Merc 18XD and 25XD Potential Hard Starting Problem

Merc 18XD

Merc 25XD

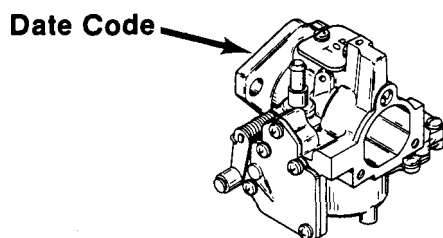
1. Only carburetors date coded December 1983 and prior may have the marginal length primer diaphragm assembly. The date code is stamped on the upper flange next to the model number (Figure 1). The last two digits indicate the year.

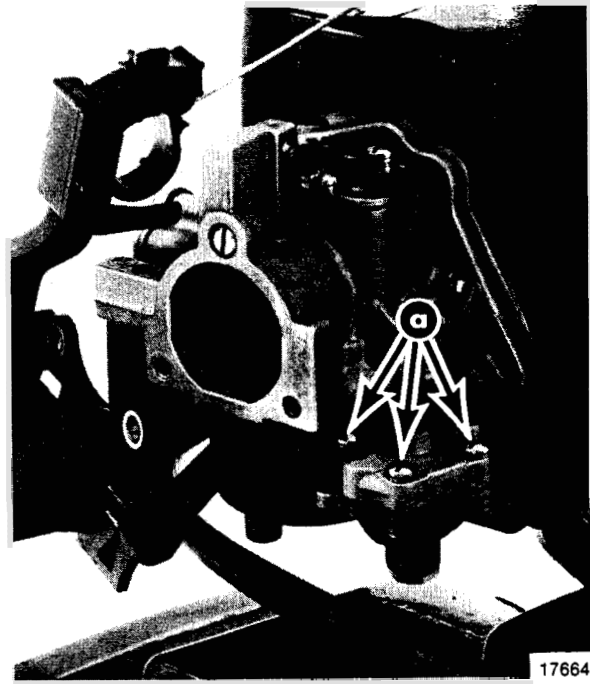
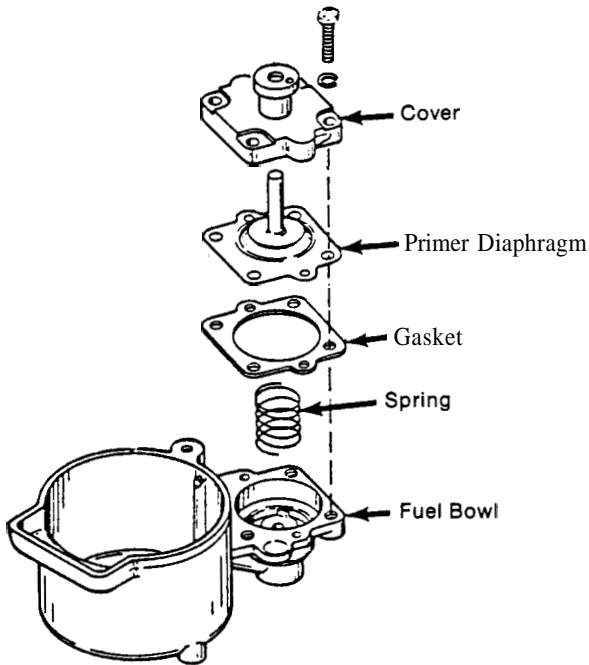
The problem occurs only if the carburetor has a marginal length primer diaphragm assembly. If the primer diaphragm assembly is too short it does not unseat the primer check ball, and the injection primer and fuel enrichment system are inoperative. Thus, the engine may not start or may be difficult to start.

6. Remove 4 screws (a) and disassemble primer system, as shown. (#1Phillips screwdriver)
7. Replace primer diaphragm and gasket with new primer diaphragm and gasket and reassemble in same order, as shown.

NOTE: Position cover so hole; on side of cover, is facing away from carburetor.
